UNITED STATES PATENT AND TRADEMARK OFFICE

APPLICATION NO.	FILING DATE	FIRST NAMED INVENTOR	ATTORNEY DOCKET NO.	CONFIRMATION NO.
10/586,843	10/16/2008	Jeremy Whiting	DEP5248USPCT	8107
27777	7590	03/10/2011	EXAMINER	
PHILIP S. JOHNSON JOHNSON & JOHNSON ONE JOHNSON & JOHNSON PLAZA NEW BRUNSWICK, NJ 08933-7003			COTRONEO, STEVEN J	
			ART UNIT	PAPER NUMBER
			3733	
			NOTIFICATION DATE	DELIVERY MODE
			03/10/2011	ELECTRONIC

Office Action Summary	Application No. 10/586,843	Applicant(s) WHITING, JEREMY	
	Examiner STEVEN J. COTRONEO	Art Unit 3733

DETAILED ACTION

Fig. 3

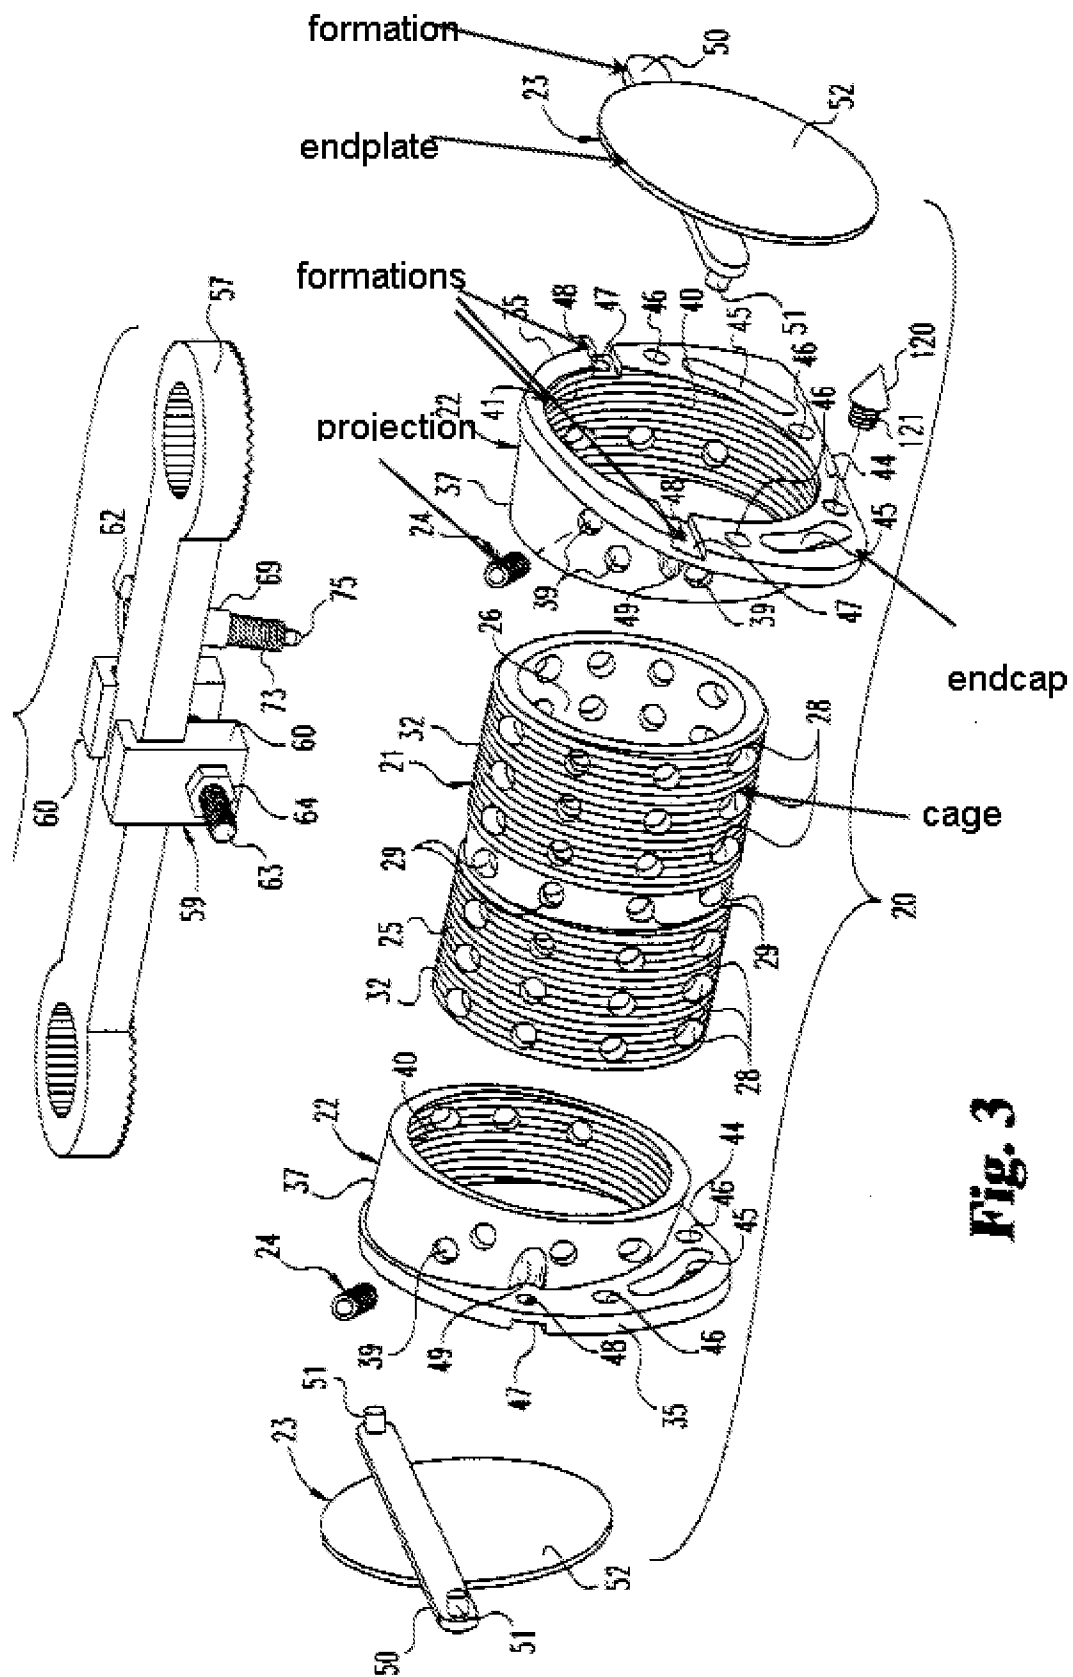
Claims 1-5 and 28-29 are rejected under 35 U.S.C. 102(b) as being anticipated by Rabbe et al. (US 5,776,198).

Rabbe et al. discloses a method for use in an intervertebral fusion surgical procedure (see fig 3 below), comprising: mounting a first and second end plate (fig 3, 23) onto a surface of a vertebra in an intervertebral space separately to an end cap, the end plate having a vertebra engaging surface (fig 3, 52); connecting a first and second end cap (fig 3, 22) to a first end of a cage, the end caps have an outermost surface and a formation (fig 3, 35, 47 and 48) adapted to mate with a formation (fig 3, 50) in the end plate; packing the interior of the cage with a material which enhances bone fusion (col. 8, ll. 29-43); and introducing the packed cage into the intervertebral space and engaging the end cap with the end plate such that the outermost most surface of the end cap is flush with the vertebra engaging surface of the end plate to present the material to the vertebral surface (col. 8, ll. 38-40). The end cap has a projection (fig 3, 24). The end cap formation is a flange around the periphery of the end cap (fig 3. 35) and has three elements (flange and the two slots 47).

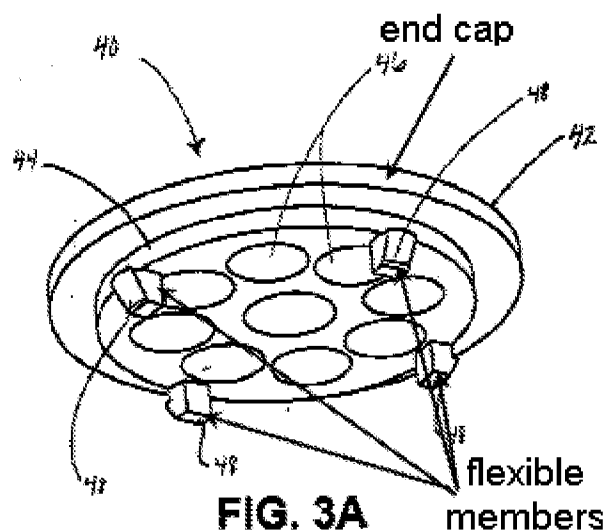
Rabbe et al. discloses the claimed invention with set screws to attach the end cap to the cage. Rabbe et al. does not disclose first, second and third flexible members to attach the cap to the cage. The cap is push fit onto the cage (paragraph 31)

Castro et al. discloses flexible members (fig 3A, 48) to connect an end cap to a cage (paragraph 31). The flexible members are separated by the same angle (fig 3A).

It would have been obvious at the time of the invention to one of ordinary skill in the art to substitute the set screws of Rabbe et al. with flexible members in view of Castro et al. because set screws and the flexible members are mere functional equivalents, and because such a substitution of one for the other would have achieved the same predictable result of connecting an end cap to a cage.
